AMENDMENTS TO THE DRAWINGS

REMARKS

FIG. 7
(PRIOR ART)

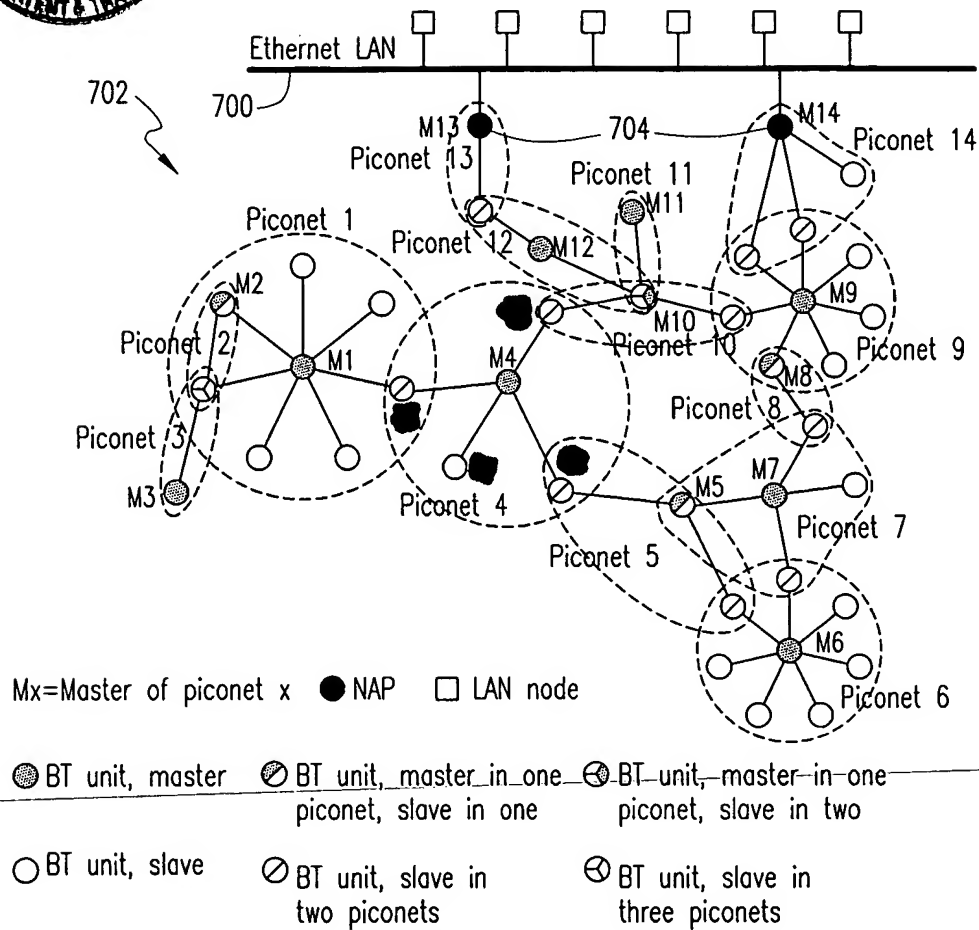
Figure 7 of the drawings is hereby amended to add the reference labels "S1," "S2," "S3," and "S4" to the four nodes directly connected to node "M4." Support for the amendment may be found in the specification in the paragraph bridging pages 31 and 32.
